CALIFORNIA COASTAL COMMISSION

STAFF REPORT AND RECOMMENDATION**ON CONSISTENCY DETERMINATION**

Consistency Determination No.	CD-014-08
Staff:	MPD-SF
File Date:	3/20/08
60th Day:	5/19/08
75th Day:	6/3/08
Commission Meeting:	5/9/08

PROJECT DESCRIPTION: Wetland and Creek Restoration at Big Lagoon: restoration of wetland, riparian, and aquatic habitat, reduction of flooding on Pacific Way, and improvements to visitor access (Exhibits 2-4)

Figure 5 : Plan View - Proposed Project

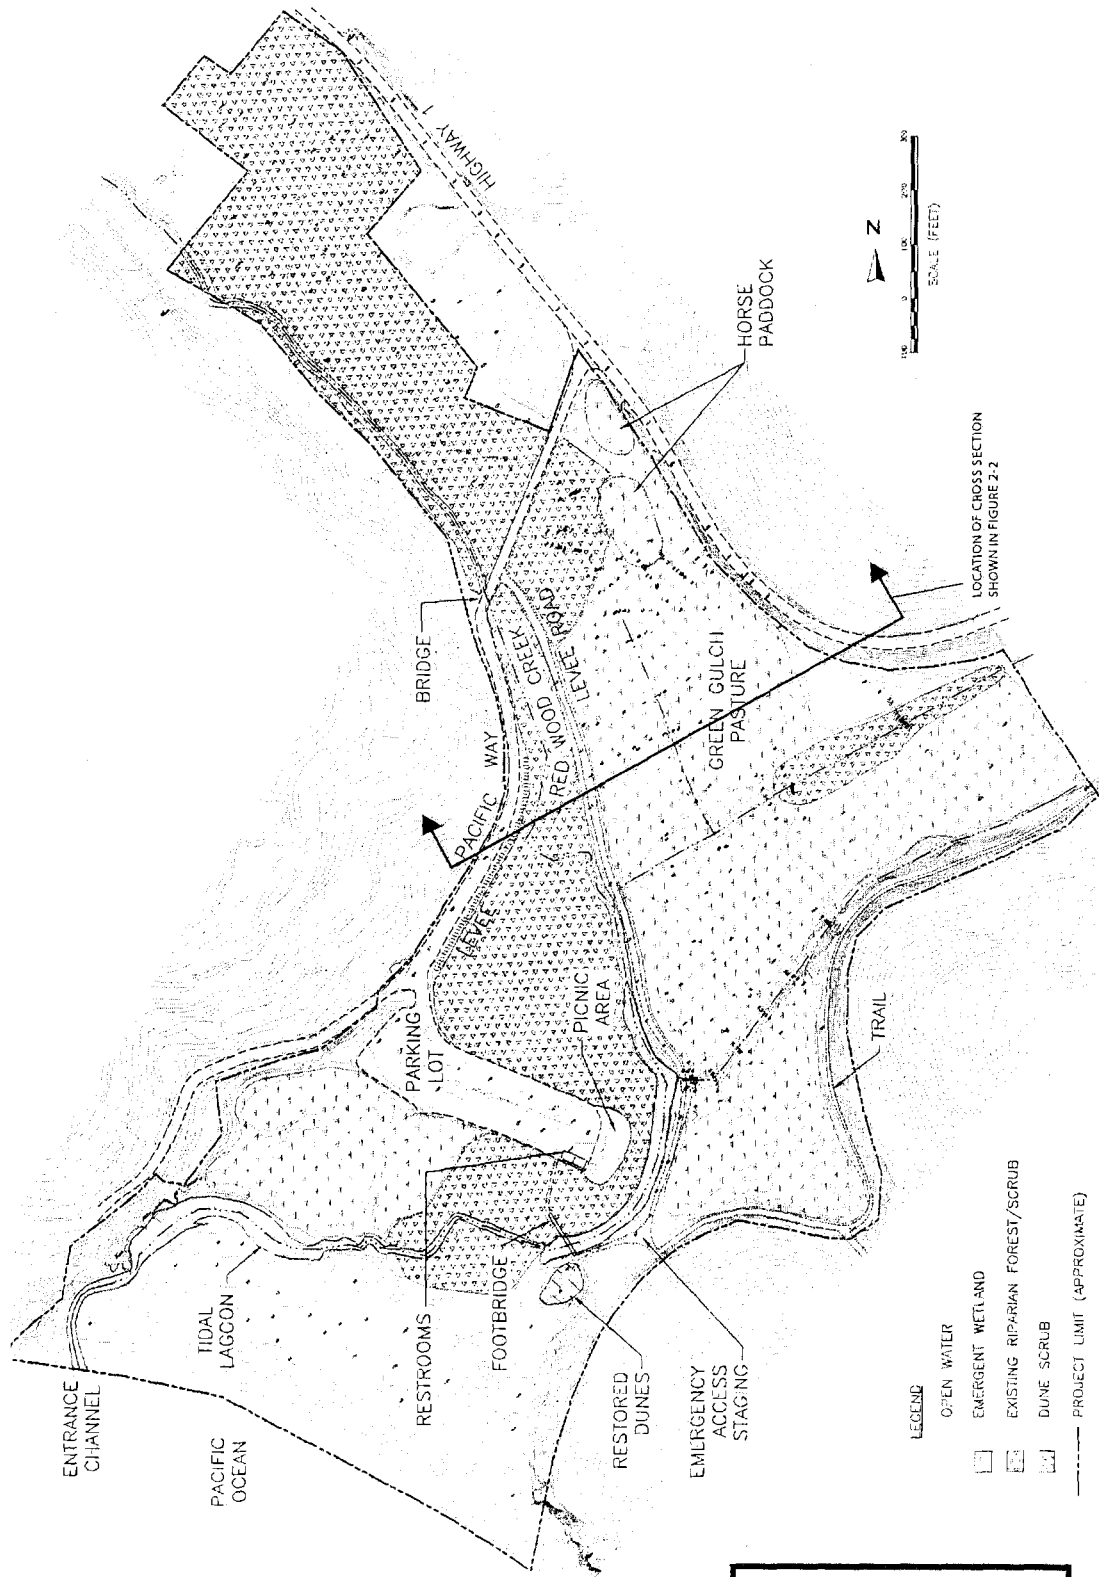
The Final EIS/EIR identifies a preferred restoration, public access and bridge alternative (Figure 5), as described below.

NPS proposes to relocate a total of approximately 2,500 linear feet of creek channel to the topographically lowest location in what will be a substantially broader active floodplain (Figure 5). This will occur in two segments, one 1,800-linear foot reach in the upper half of the project area, and the second, downstream of the parking lot (about 550 feet) connecting to the tidal lagoon. The tidal lagoon will also be enlarged through excavation. Both the lower channel relocation and the excavation associated with enlarging the tidal lagoon will connect to and become navigable waters subject to Section 10 of the Rivers and Harbors Act. The upper extent of Section 10 jurisdiction is at the elevation of 2.5 feet NGVD.

Excavation is proposed along the landward side of the intermittent tidal lagoon to enhance its natural variability (Figure 5). An approximately 100-foot wide swath would be excavated along the entire 200-foot length of the north side of the lagoon. The excavation depth would be as much as 4 feet, or somewhat deeper than the roots of the existing vegetation, dominated by salt tolerant species such as salt grass (*Distichlis spicata*) and rush (*Juncus lesurii*). The excavation would expand the open water lagoon by up to about 0.46 acres, but it is expected to vary in size seasonally and as a result of interannual variation in flows and sediment loads. Wave action and inundation by lagoon water would discourage vegetation establishment, allowing windblown sand to reconstruct the historic dune field. Large log structures are also proposed to be installed in the tidal lagoon to create scour pools and cover favored by coho salmon in such habitats.

Some remnants of the non-historic Muir Beach Tavern in this area adjacent to the existing parking lot would also be removed to enhance the natural wetland function (Figure 5). The remnants include the concrete sidewalks, and a concrete retaining wall or curb along the northern side of the mouth of Redwood Creek. Remnants of the tavern chimney would not be removed. Heavy equipment would be used to remove these features, and ground contours restored to match those of surrounding floodplain. Up to about 0.01 acres of wetland would be gained by this action.
